## **Planning Board – Monday, November 23, 2020, 6:30PM**

## SPR-963, MODIFICATION #3 – SITE PLAN REVIEW – 345 Winchester Street – Sunoco Gas Station, Modifications to Curb Cut

**PROJECT:** SPR 963 Modification 3, 354 Winchester Street  
Sunoco Driveway Modifications  
Winchester Street Reconstruction Project

**RE:** Response to Comments

**SUNOCO ADDITION PLAN  
 WINCHESTER ST. SUNOCO**

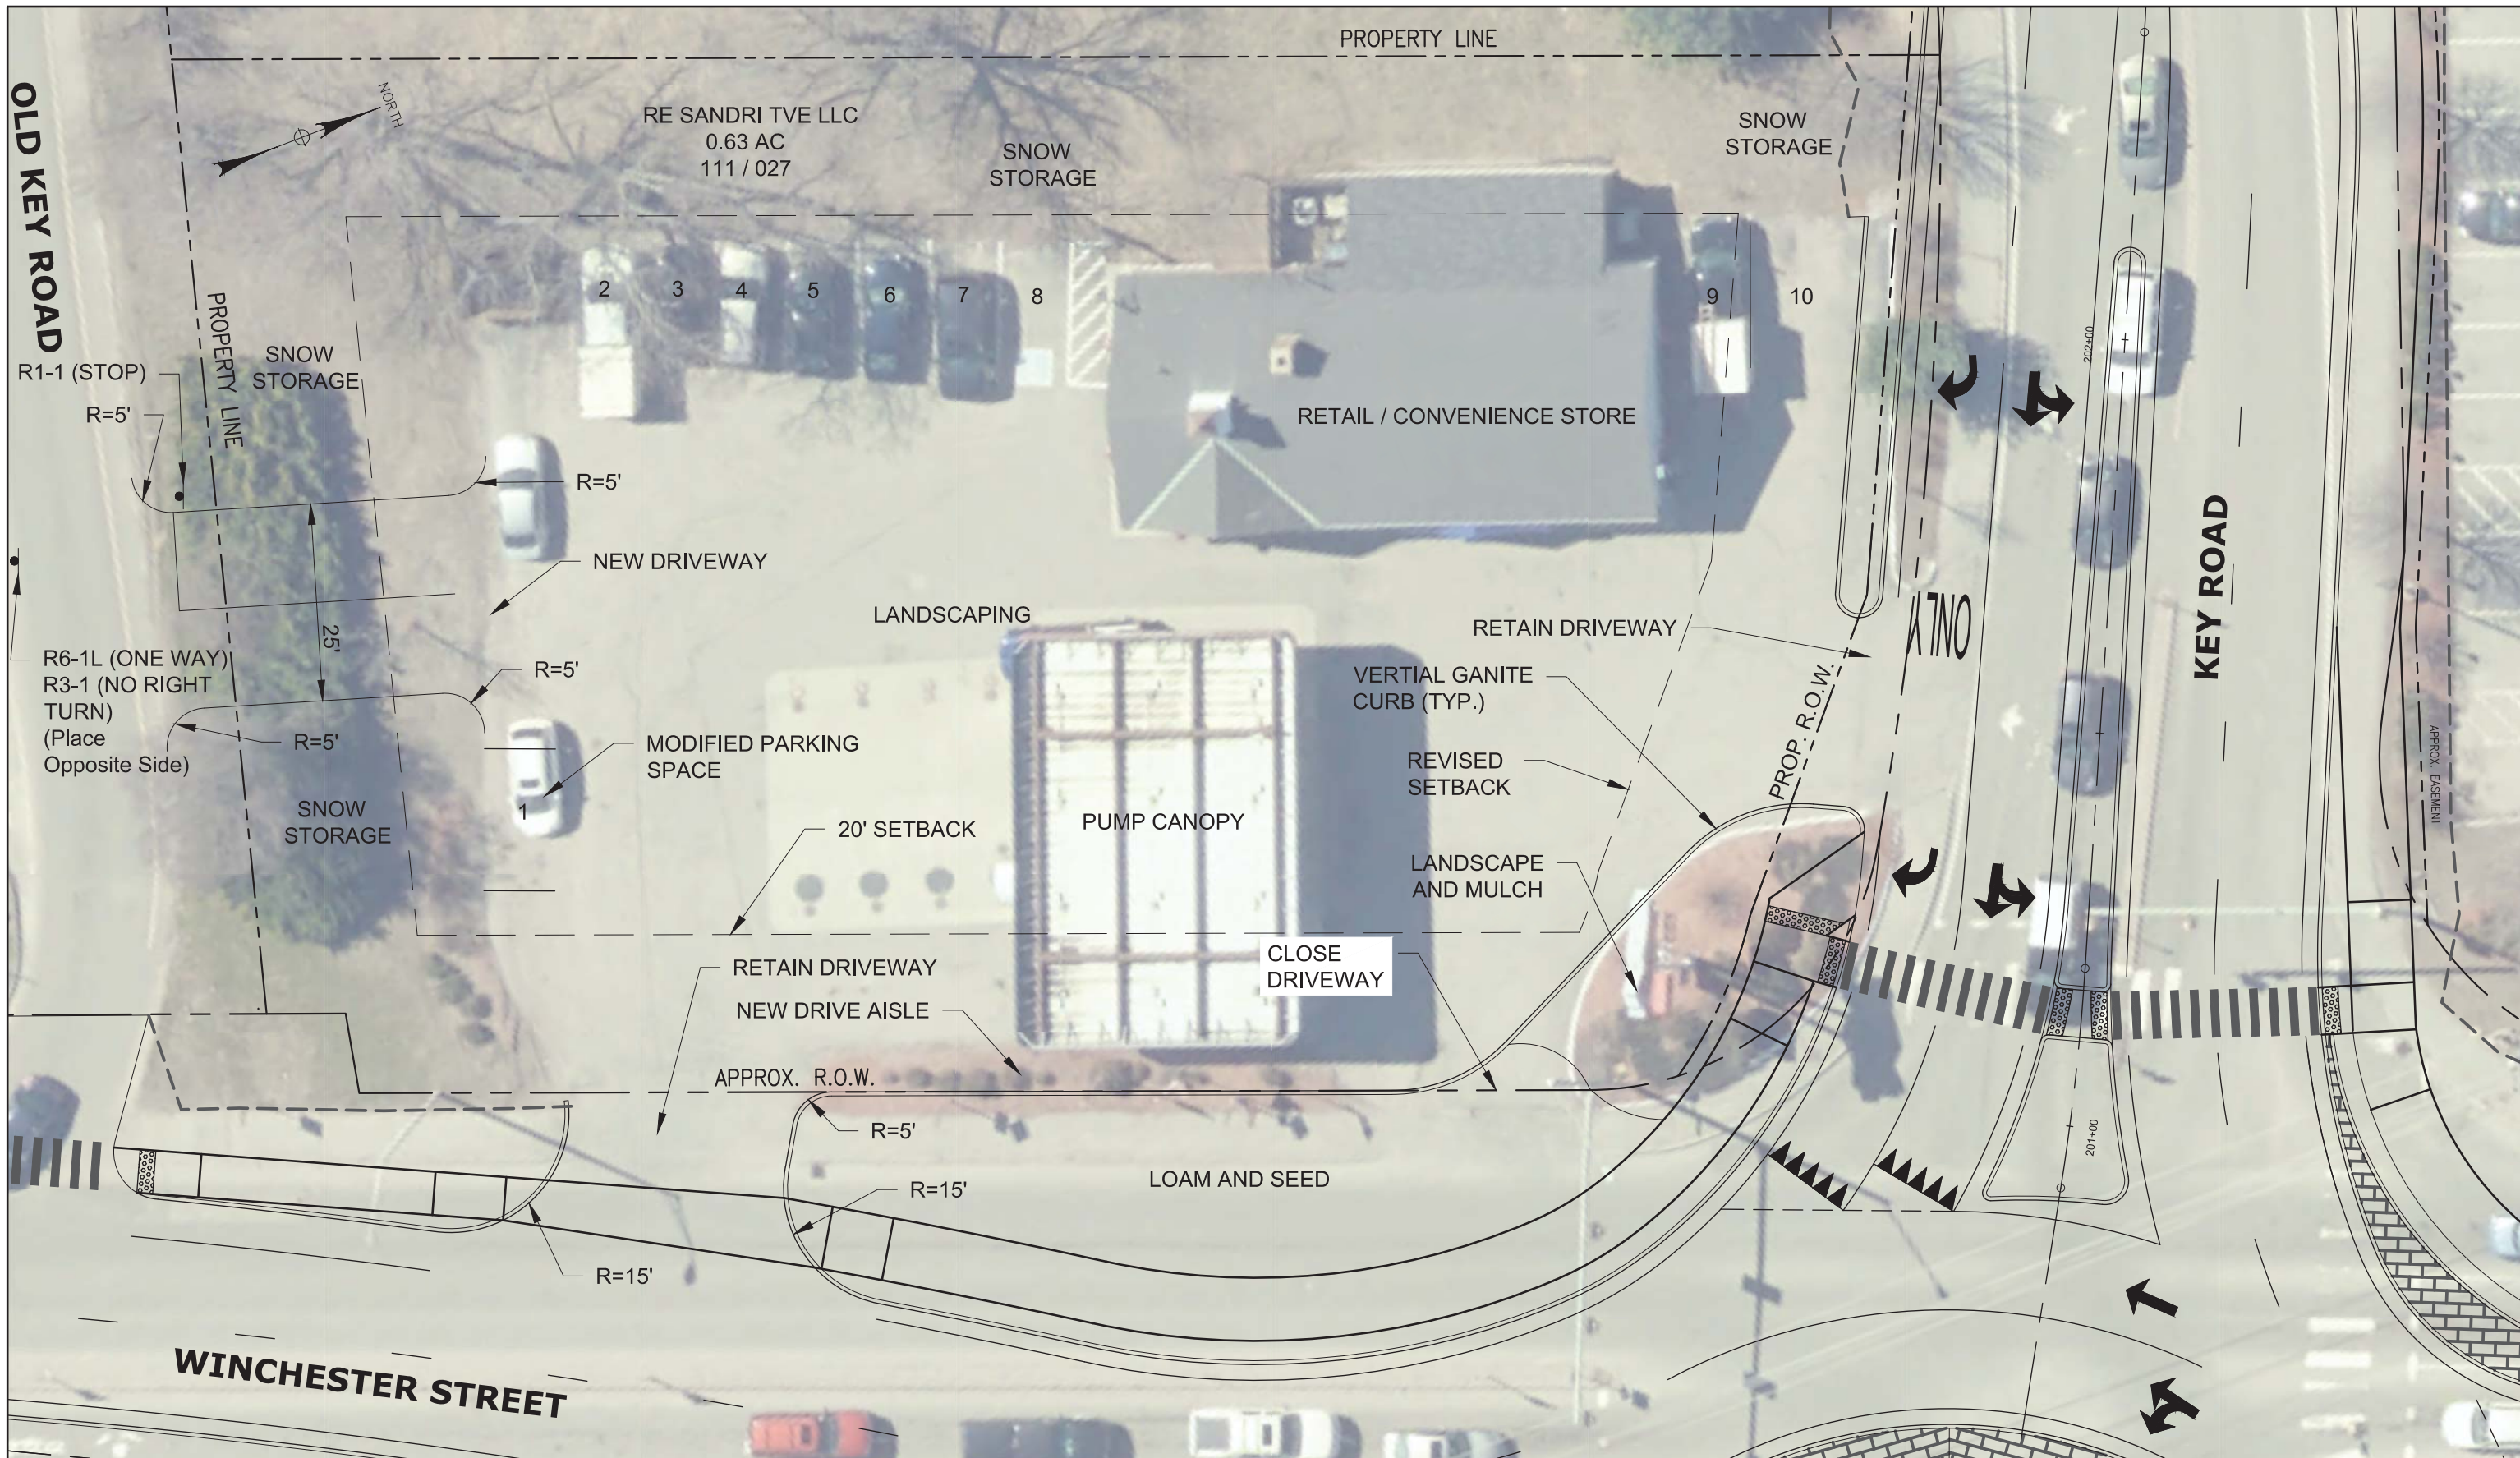
3. The narrative states that the flow of stormwater “will be directed to a new stormwater pond that will treat the discharge.” There is no detail or information regarding this drainage system on the site plan. Please submit a drainage and grading plan for the site, and more information regarding the location and design of the stormwater pond.

5. Regarding landscaping – The existing conditions plan submitted does not display the existing landscaping on the site nor does the proposed site plan display the landscaping that will be removed and replaced as part of this proposal. For your reference, I have attached the most current site plan that displays the approved landscaping for this site. No modifications have since been approved by the Planning Board or City staff to this landscaping plan. Please submit a landscaping plan that details the number, species, size at planting and maturity, and location of the proposed plants. It is our understanding that no new landscaping is proposed; however, the narrative states that landscaping will be replaced and the site plan includes a note stating “landscape and mulch” near the corner of Key Rd and Winchester St, with no further details.

6. Regarding screening - It appears that the existing landscaping along Winchester Street will be removed. These plantings were included in the original site plan as screening of the gas station pumps from Winchester St. How will the pumps be screened from Winchester St as part of this proposal? Will this landscaping be replaced in the City right-of-way, as the proposal reduces the space available on the site for such screening?

**Response:** The included Utility Plans depict the proposed drainage improvements along Winchester Street and the new stormwater pond located on the opposite side of Winchester Street.

Response: The current landscaping that is to be impacted by the project appears to be newer than the prior approved landscaping. The existing landscaping in the northeast quadrant of the site will be relocated as part of the roadway project. There are no new plantings proposed by the project. The new open area within the Winchester Street Right-of-Way will have grass only.

Response: The current landscaping along Winchester Street will be removed, however, the existing landscaping in the northeast quadrant of the site will be shifted to allow for the construction of new sidewalks. The existing plantings provide minimal screening of the pumps as can be seen in the photo below. There is therefore no additional landscaping proposed to screen the pumps.
